SUNNYSIDE GOLD CORPORATION
AN ECHO BAY COMPANY

April 4, 1995

RE: Discussion Items for May 17, 1995 Meeting

Settlement Flow Chart
Sunnyside Gold Corporation

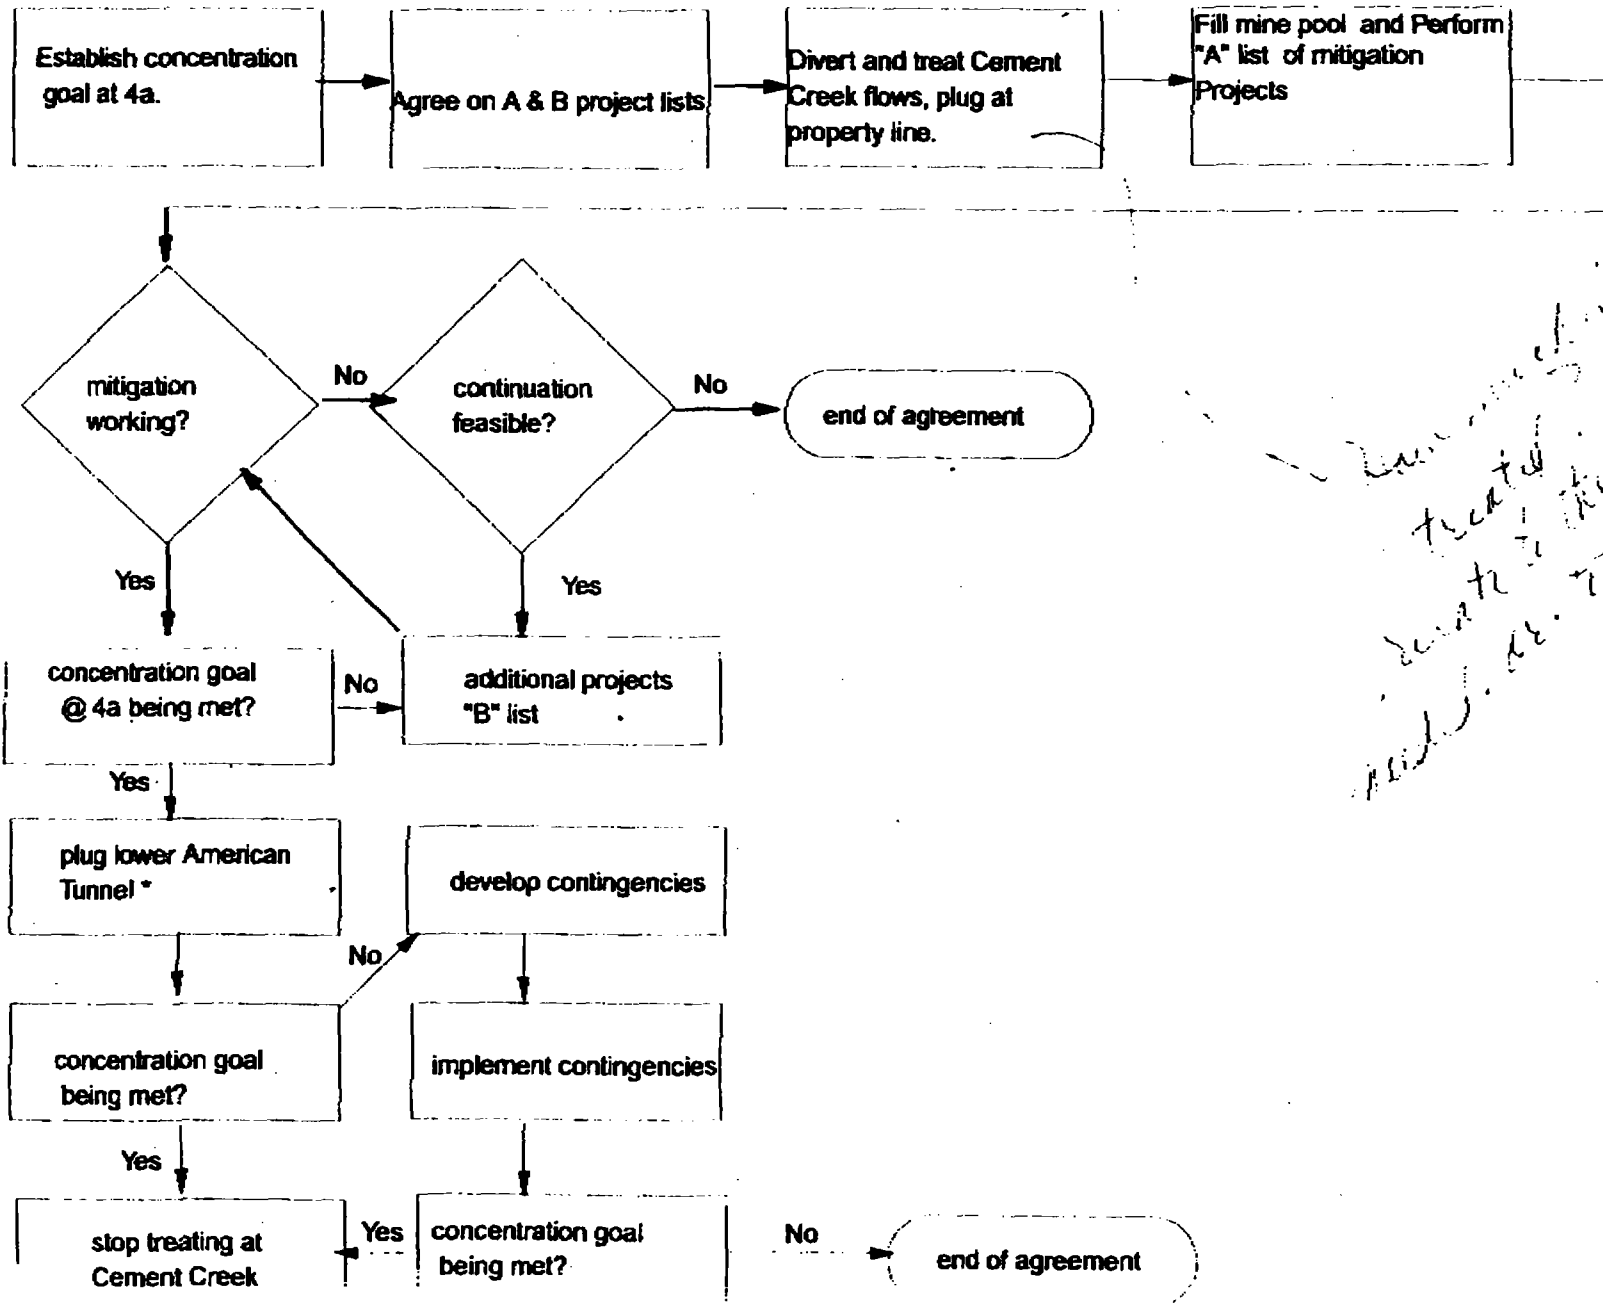
Handwritten note:
 "Can we make
 treated water
 route to the mining
 pool. Or take samples"

* plugging of lower American Tunnel may not be necessary
